COMMONWEALTH OF AUSTRALIA
DEPARTMENT OF TRANSPORT
AIR TRANSPORT GROUP

Airworthiness Directive Gliders

GFA/FFA 3/74

F.F.A. Diamant 16.5 & 18.

AD. GFA./FFA 3/74

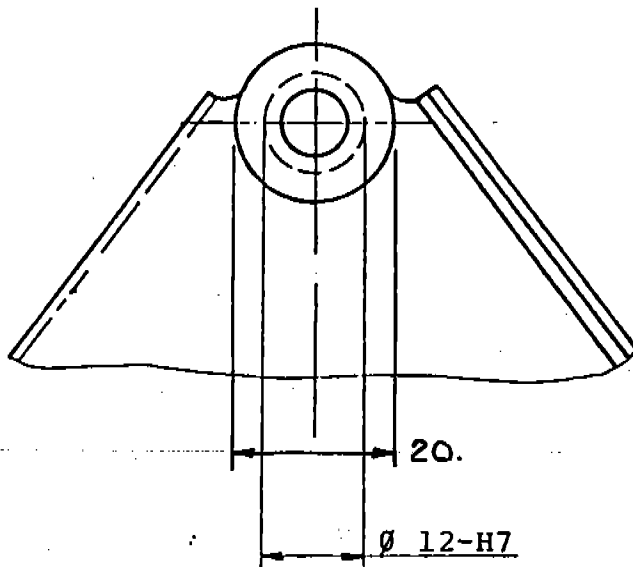
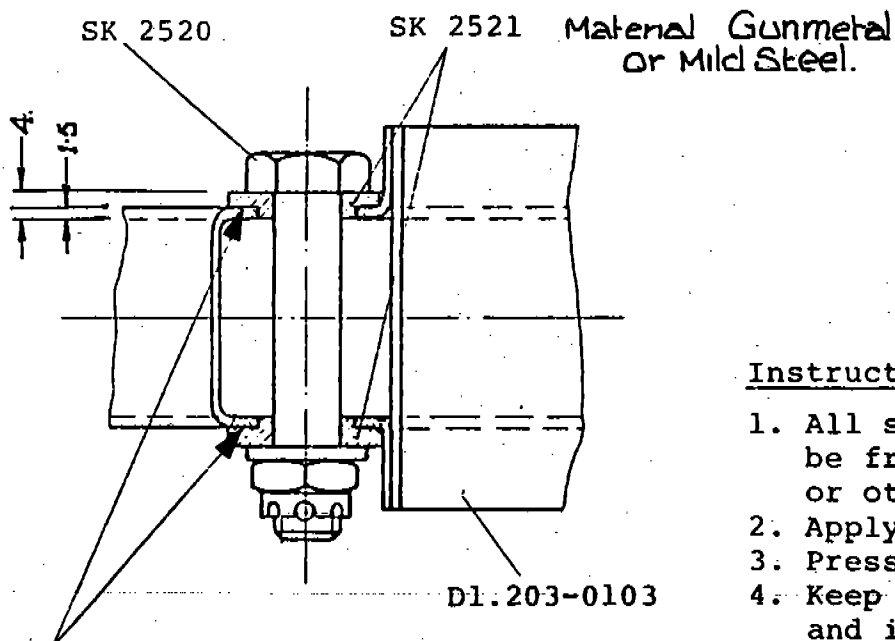
Reason : The stick control of one DIAMANT sailplane had too much play. The result of an exact investigation was showing wear of the stick bearing in the torsion tube.

1. Inspect stick control for excessive play immediately after receipt of this Service Bulletin.
2. If the stick bearing shows normal play the inspection must be repeated every 50 flight hours.
3. If the stick bearing shows play accomplish the modification in accordance with para 4 before the next flight.
4. Modification:
 The present two holes in the torsion tube D1.203-0103 must be drilled and reamed to the diameter of 12-H7 ($12 + 8,018$ mm).
 According to the attached drawing, two bushings SK 2521 have to be bonded into the torsion tube. Due to the new dimension of the bearing depth, the pivot bolt D1.203-0106 must be replaced by a new bolt SK 2520.
5. The inspections according to para 2 are no longer necessary if modification has been carried out.

Instruction for bonding:

1. All surfaces to be bonded must be free of paint, oil, grease or other foreign substances.
2. Apply the adhesive.
3. Press in the bushings.
4. Keep the bore of the bushings and inner surface free of adhesive.

DIAMANT. SEAT BELT FIXTURES.

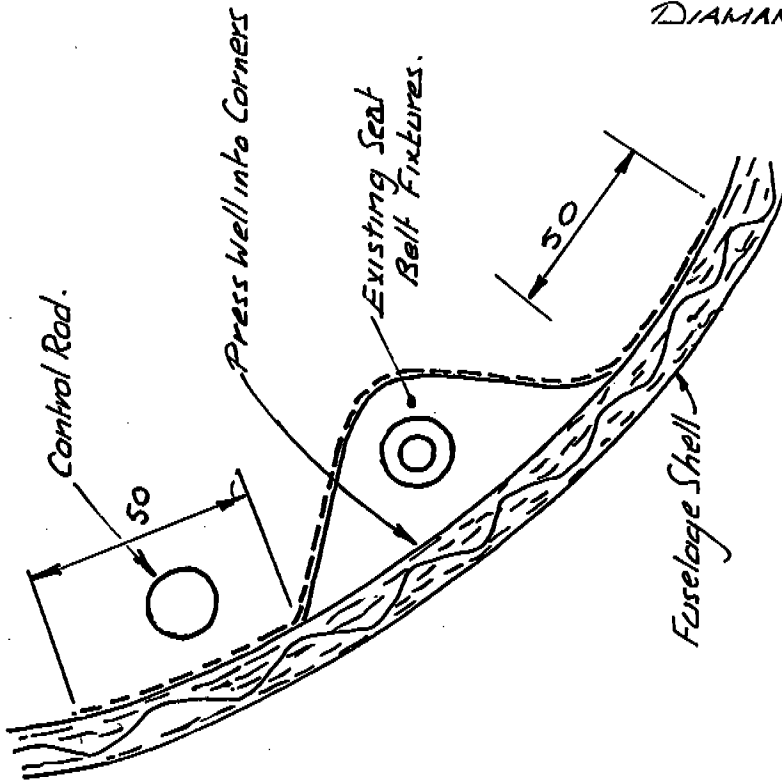
REASON : The lower harness attachments of a DIAMANT sailplane can be loose due to an incident. The investigation showed that the bonding of the attachments was insufficient.

A reinforcement of every lower harness attachment is required since checking the bonding of all active DIAMANT sailplanes is not possible.

- : Two each fiberglass clothes 140 diagonal have to be laminated across the harness attachments in accordance with the attached drawing SK-HBV 189:
1. Remove LH and RH sidewall panels.

7. Sand fuselage and harness retaining area to the size of the reinforcement laminate.
 8. Cut to size glass clothes in accordance with the attached drawing SK-HBV 189.

9. Laminate tailored fiberglass clothes with Araldit resin LY 554 (5 parts) and Araldit hardener HY 554 (1 part). Minimum temperature for bonding procedure is $20^{\circ}\text{C} = 68^{\circ}\text{F}$.

2 Fabrics X
Laminated.

To be cut out after
Laminating
